THE PORT AUTHORITY OF NY & NJ
PROCUREMENT DEPARTMENT
2 MONTGOMERY STREET, 3RD FL.
JERSEY CITY, NJ 07302

ADDENDUM # 4

To prospective Bidder for Bid # 40517 entitled, “Manufacture and Deliver Four (4) Switching Locomotives and Associated Spare Parts for PATH”:

OHIO BRASS
MECHANICAL COUPLER ASSEMBLY
FORM 8501

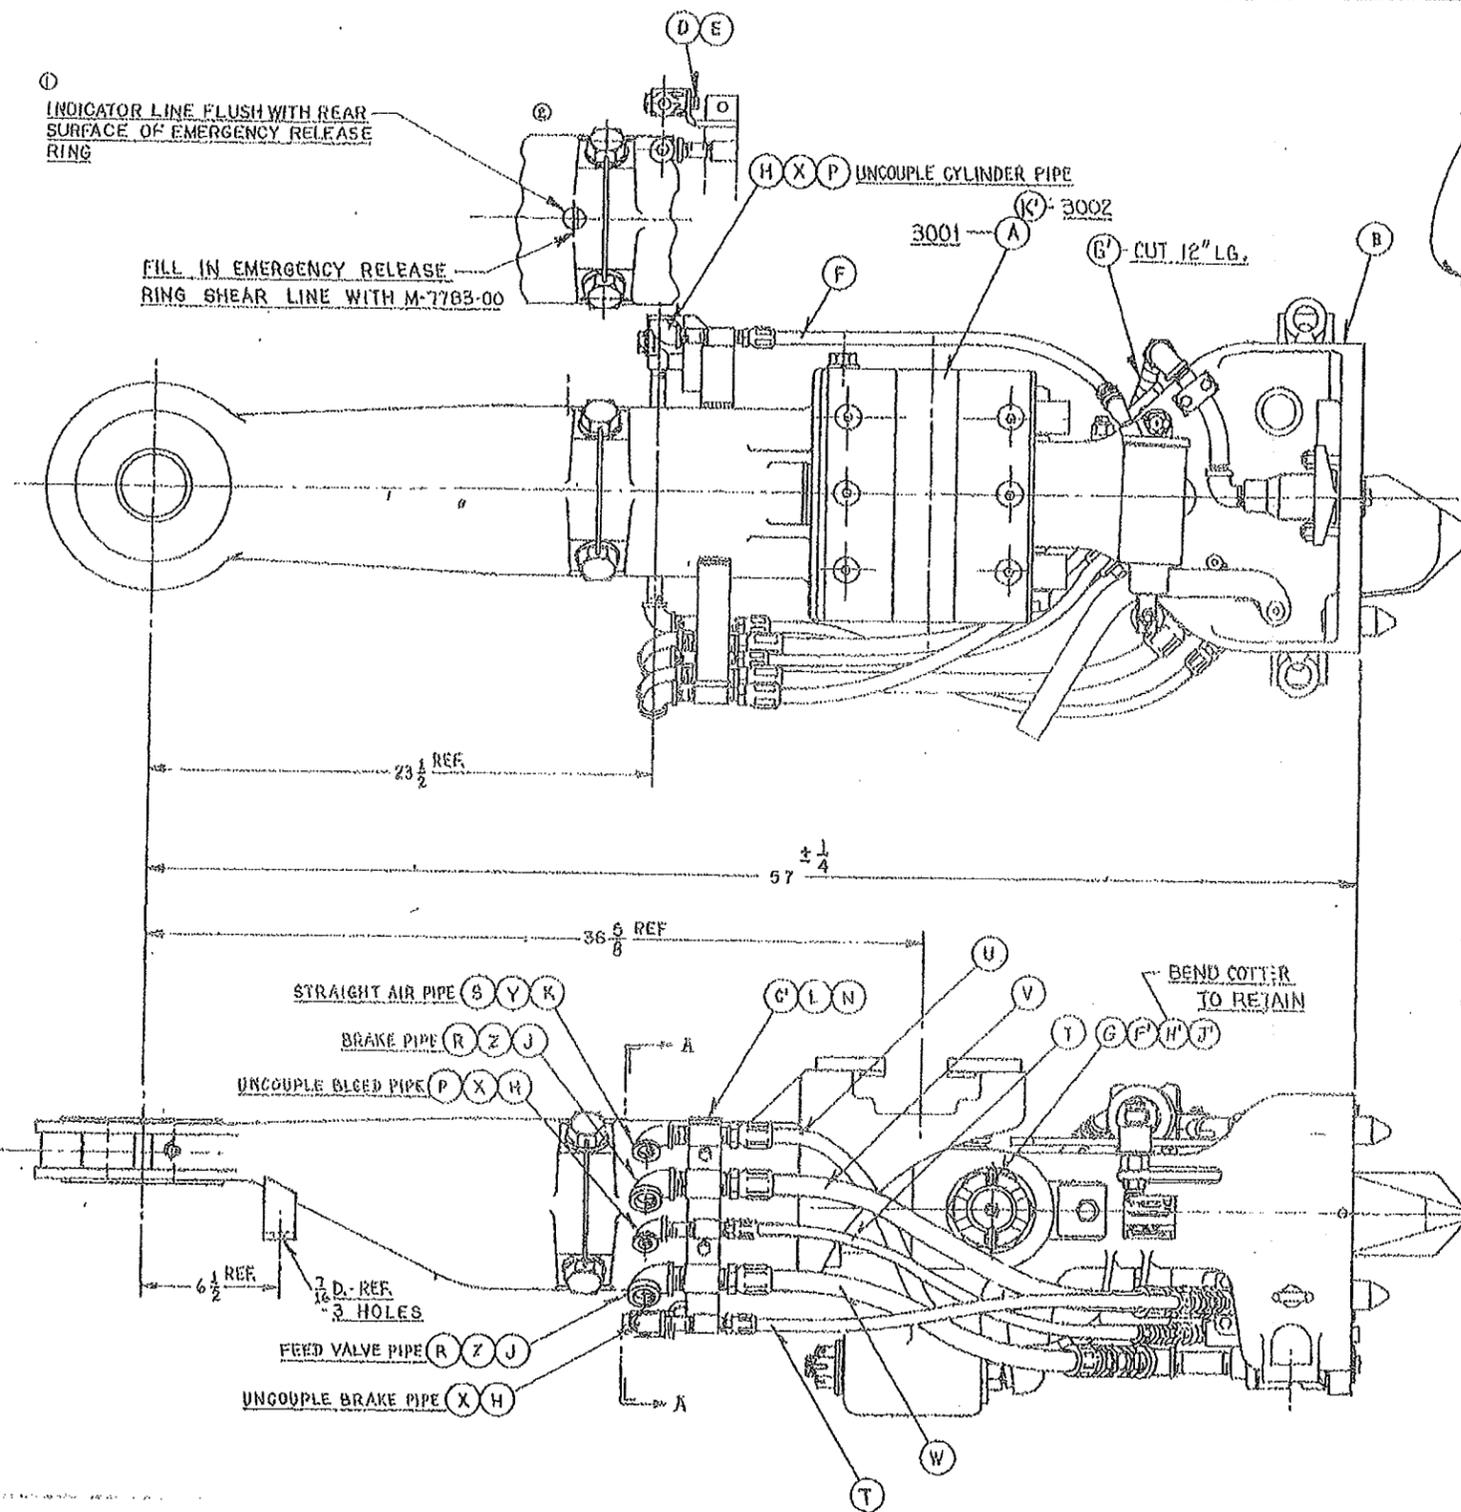
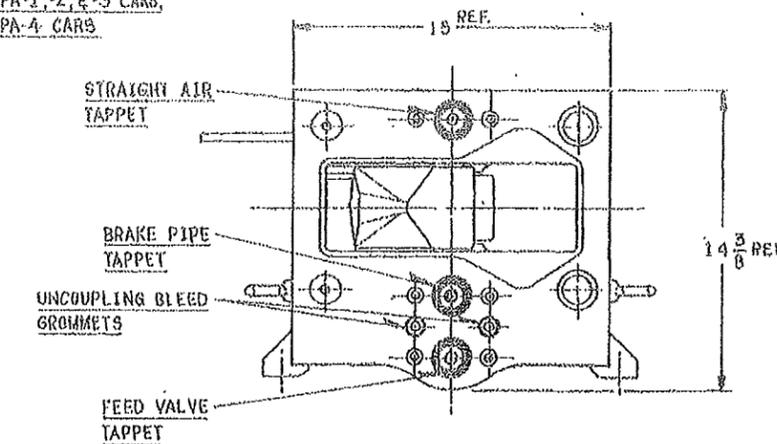
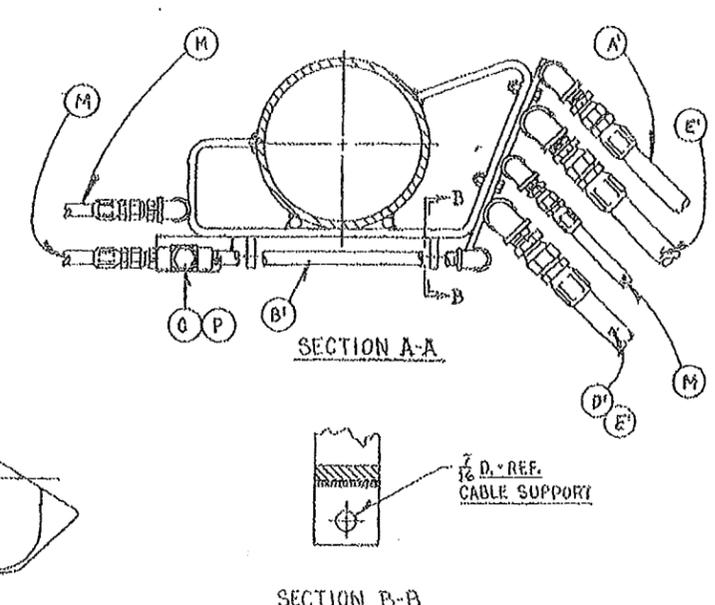
- L. Part V – Specifications, Section 5.1, General, third paragraph, first line, after “Hook type coupler” add “(see drawing P-0009-1)”.
- M. Part V – Specifications, Section 6.4.1, Cab Seat, in the first paragraph second sentence after “Model # 9100-100004-000”, add “or approved equal”.

W. Delete drawing “P-0009” and replace with “P-0009-1”.
